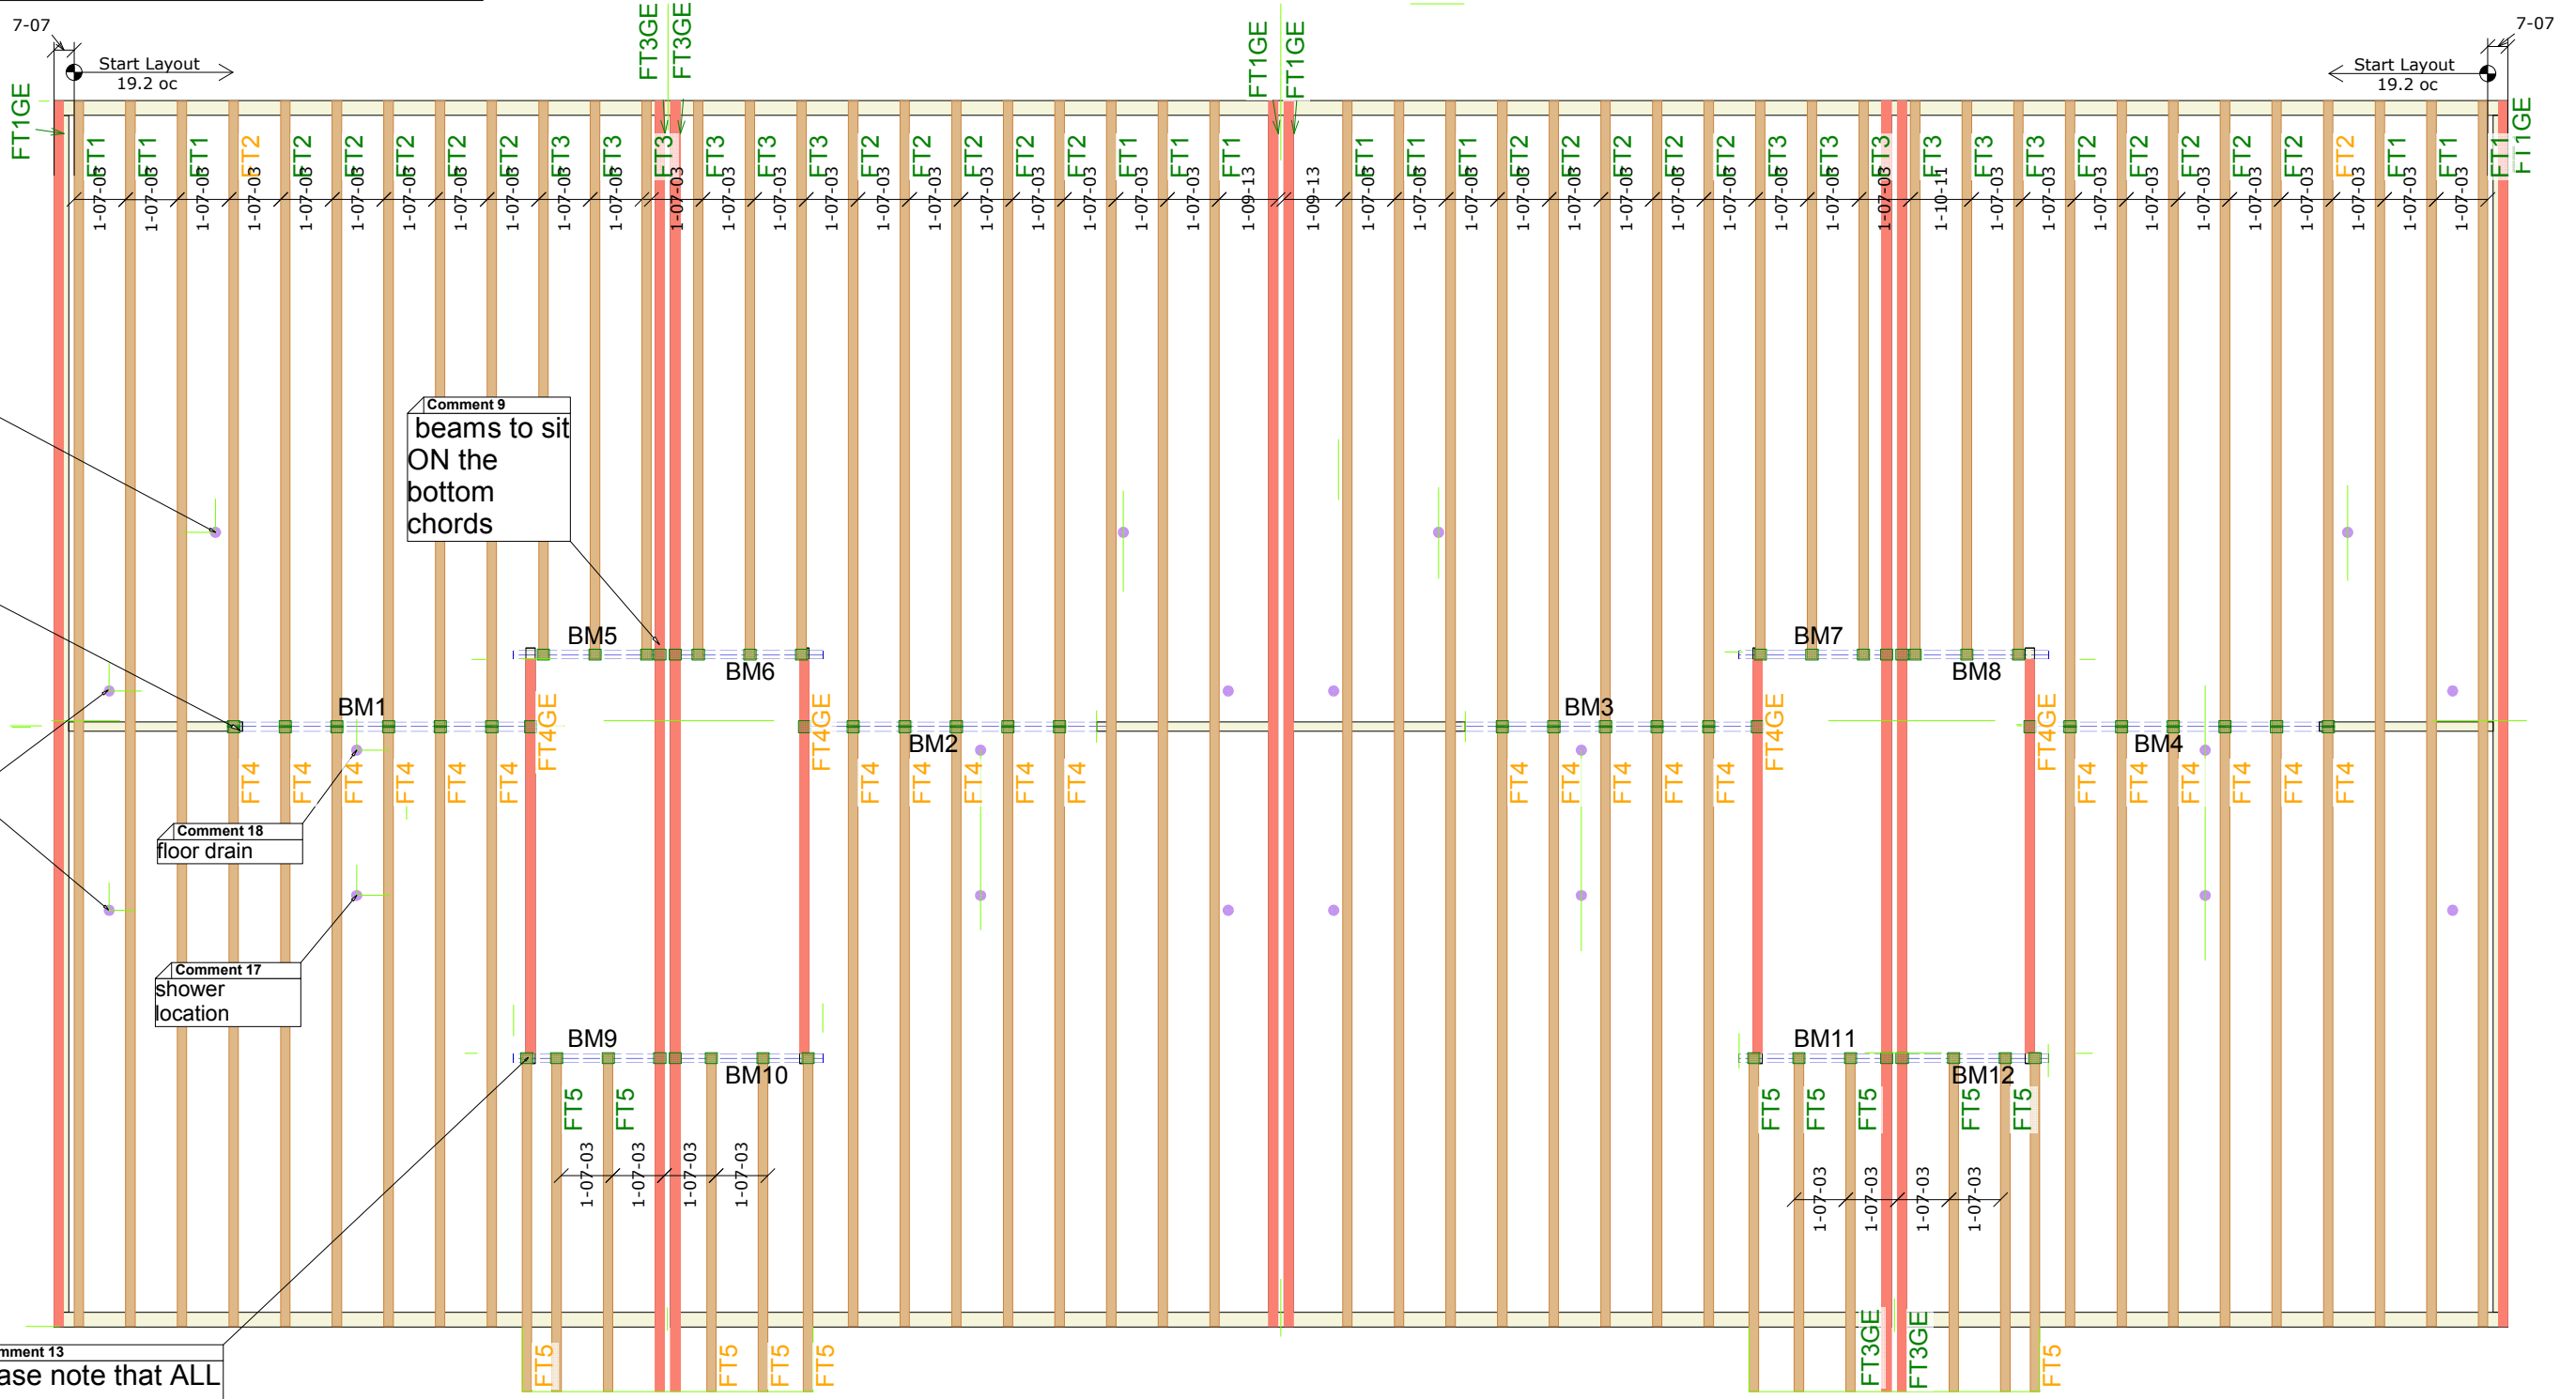
Comment 8  
please note layout to miss toilet and tub locations

Comment 11  
please note that the area under the beam will need to have an additional top plate to the face of the FT1

Comment 19  
tub location

Comment 9  
beams to sit ON the bottom chords

Comment 1  
toilet location

Comment 18  
floor drain

Comment 17  
shower location

Comment 16  
All trusses MUST be installed directionally correct

Comment 13  
please note that ALL beams are cantilevered past the wall 5 1/2"
